Access Compliance Report

Public Rights-of-Way

(Curb Ramps)

Intersection ID: 28253	Main Street: EASTON GREY LN	Cross Street: PEMSWOOD ST	Location: SW
ADA ID: DA42272DAAC0	Ramp Type: PerpDiag	Initial Pass/Fail: Pass	Overall Compliance: No
Severity Score: 10			
Codes/Mitigation Info/Possible Solution		Field Measurements/Component Compliance

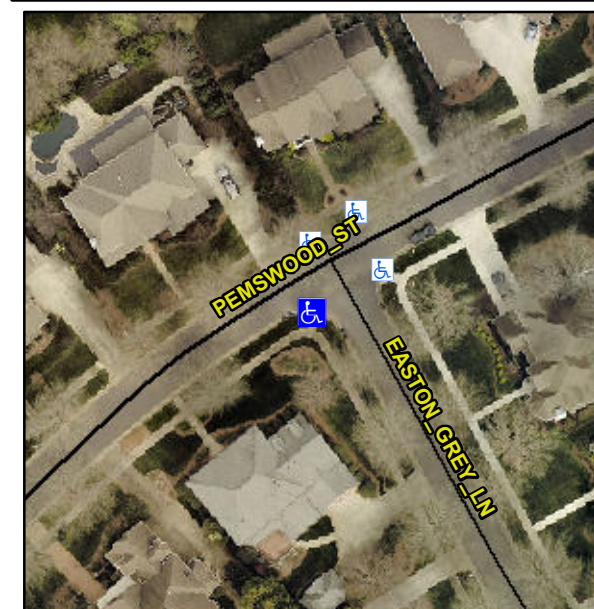
Remove & Replace Curb Ramp With Two New Directional Ramps or Equivalent. Gutter Ponding Observed.
